LF PCN# A0133a Notification of change to Font tonality on MEGA fuse

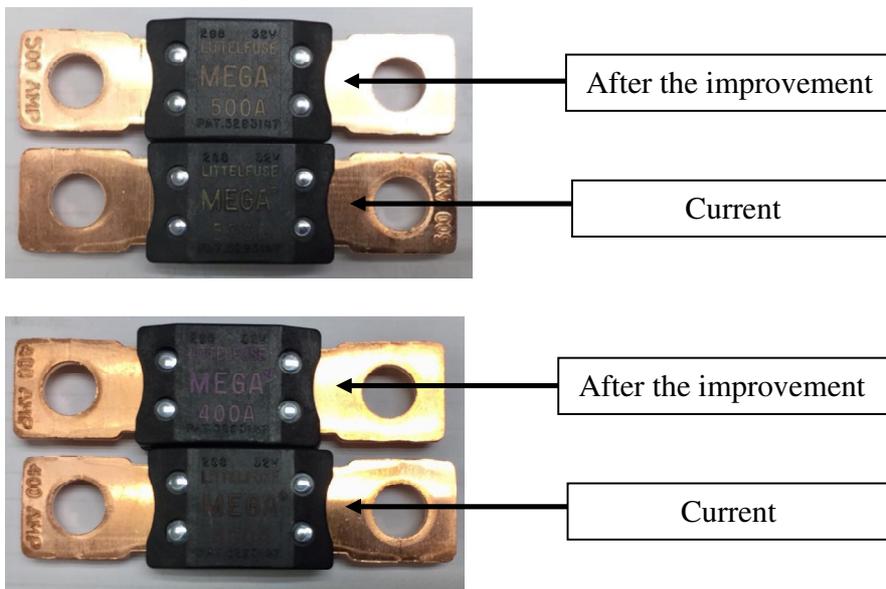
Dear Valued Customer,
Littelfuse Inc. would like to notify you of a change in the font tonality of the rating mark on some of the MEGA fuses. Littelfuse is changing the rating mark font tonality to improve the contrast against the black resin of the housing for better performance at our customer's automated vision inspections.

Below are a couple of examples showing the improvement:

This change will be implemented as a running change and will start producing parts with this improvement by **October 2, 2017**.
